TENNESSEE VALLEY AUTHORITY SEQUOYAH NUCLEAR PLANT (SQN) UNITS 1 AND 2 DOCKET NOS. 327 AND 328

PROPOSED TECHNICAL SPECIFICATION (TS) CHANGE 00-14 DESCRIPTION AND EVALUATION OF THE PROPOSED CHANGE

PROPOSED TECHNICAL SPECIFICATION (TS) CHANGE
MARKED PAGES

FIGURE 3.4-2 SEQUOYAH UNIT 1 REACTOR COOLANT SYSTEM HEATUP LIMITATIONS
APPLICABLE UP TO 16 EFPY

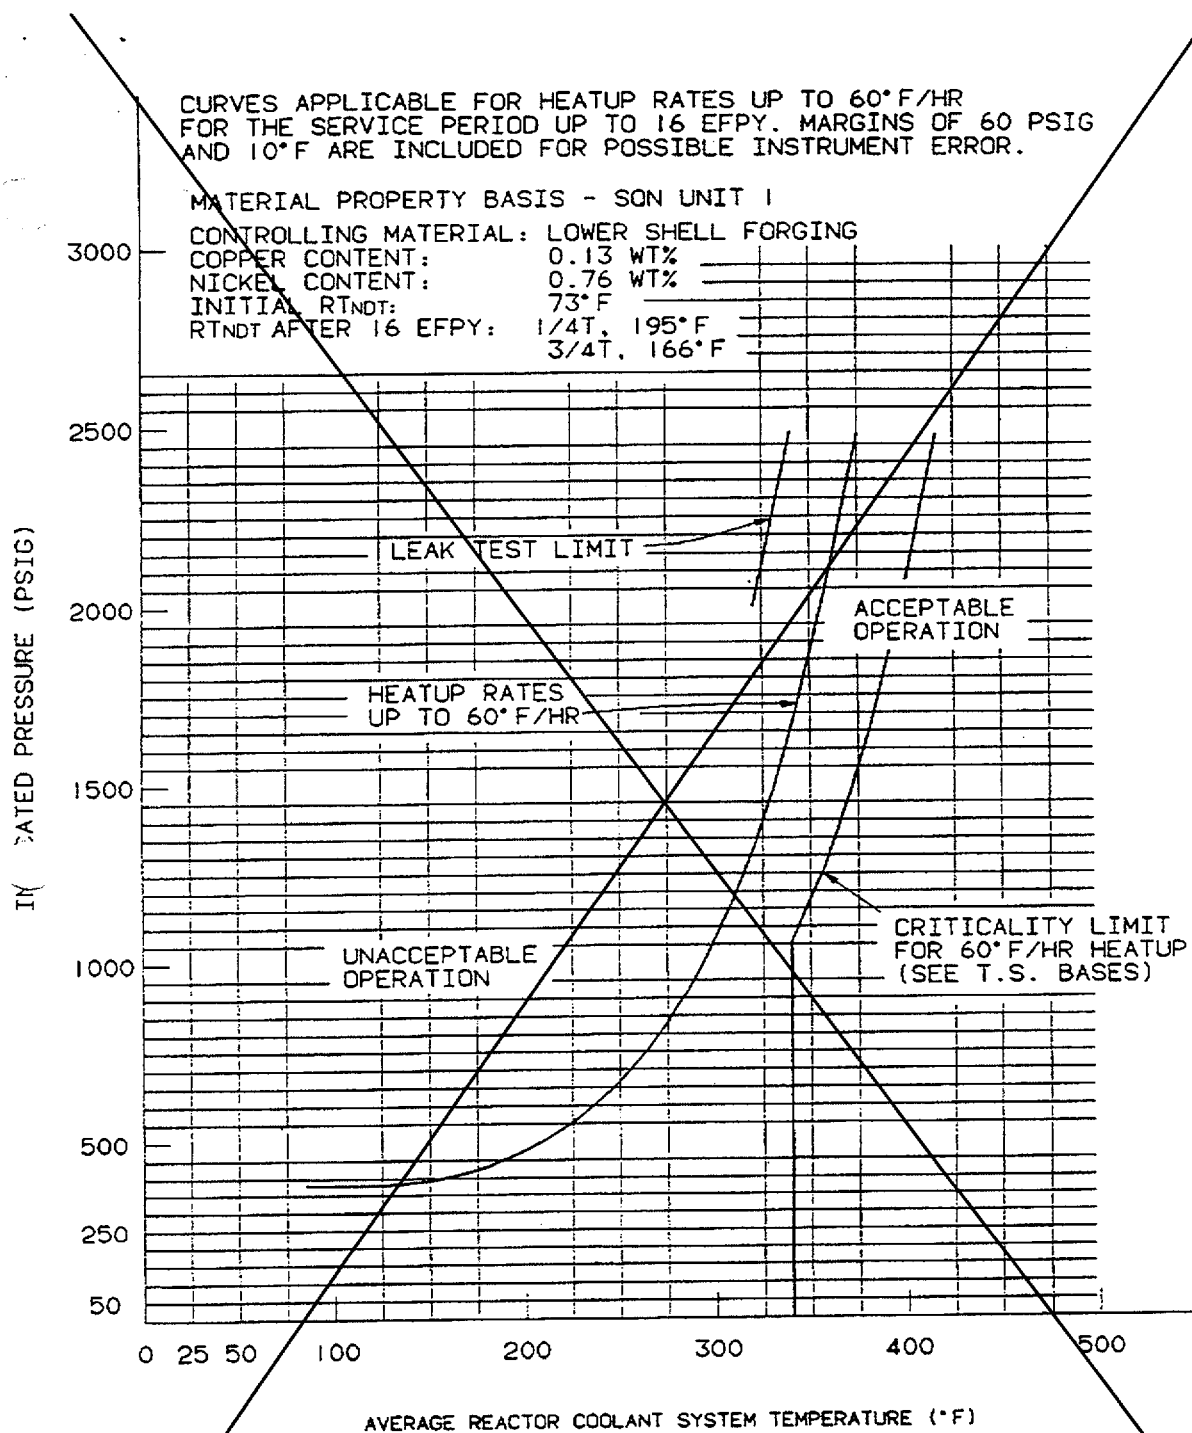
The standard LCO simplifies the current LCO language and deletes the references to SQN TS Figures 3.4-2 and 3.4-3 (RCS heatup and cooldown limit curves). The limit curves are relocated and retained within the PTLR. The relocation of these curves is acceptable based on the guidance from NRC GL 96-03 (refer to previous discussion of GL 96-03). In addition, the RCS temperature rate-of-change limits are relocated to the PTLR. It may be noted that the temperature rate-of-change limit associated with the in-service leak and hydrostatic (ISLH) testing increases to 10°F from the current 5°F value. The 5 degree increase is justified because it is accounted for in the enclosed P-T limit analysis. The rate-of-change temperature value is an assumed parameter that provides input to the calculations for development of the P-T

FIGURE 3.4-2 - DELETED

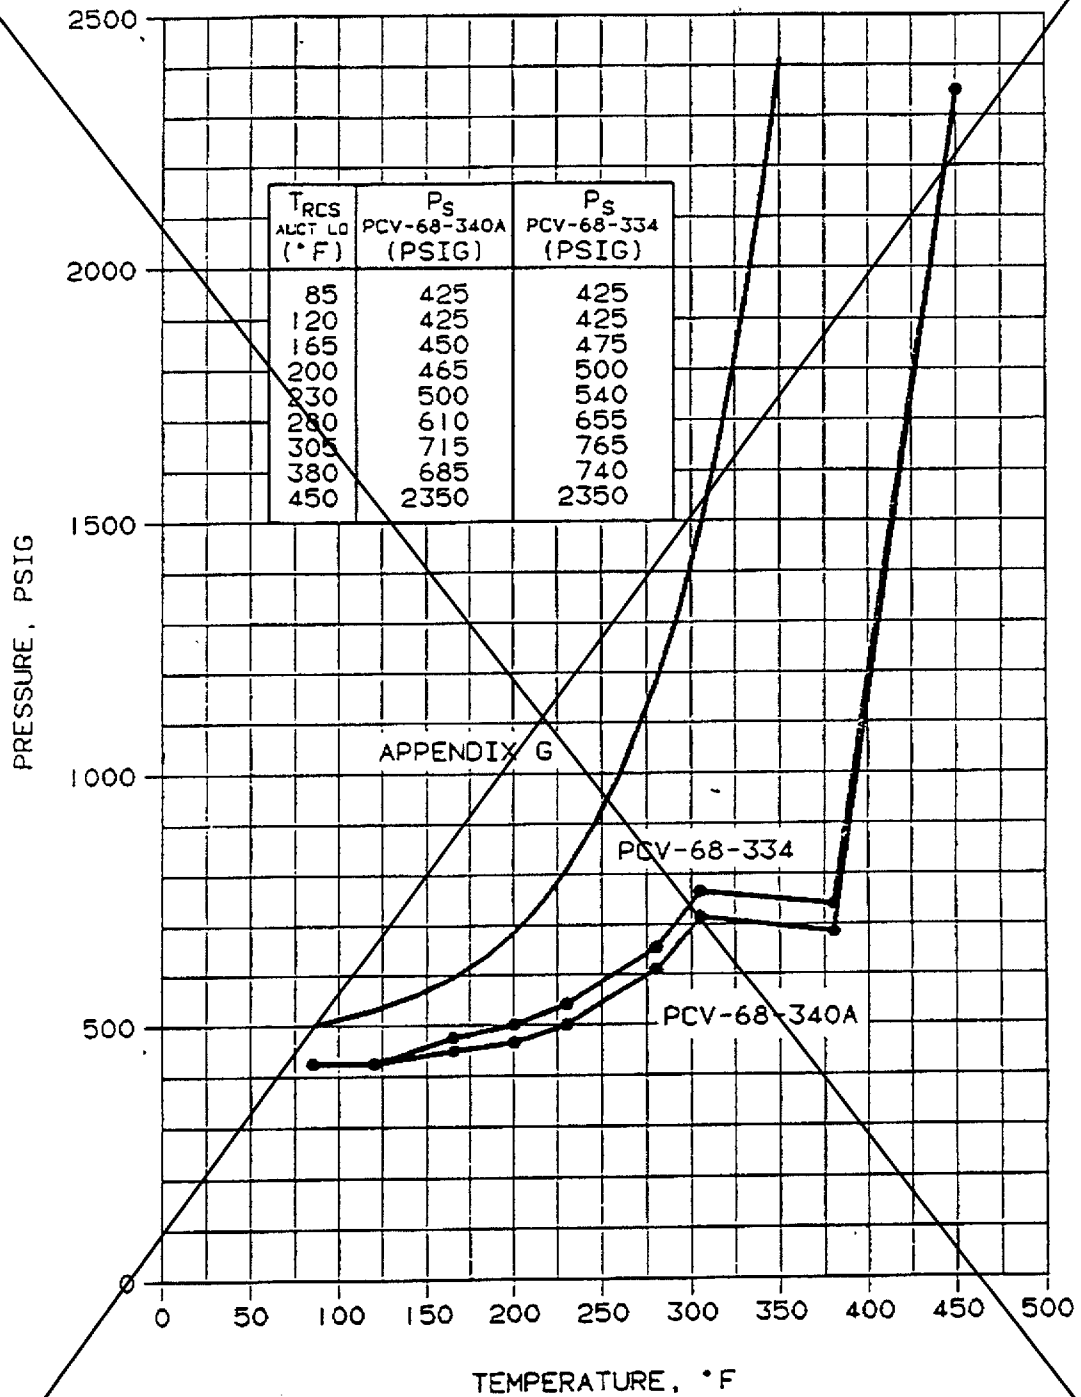
Delete Figure 3.4-4
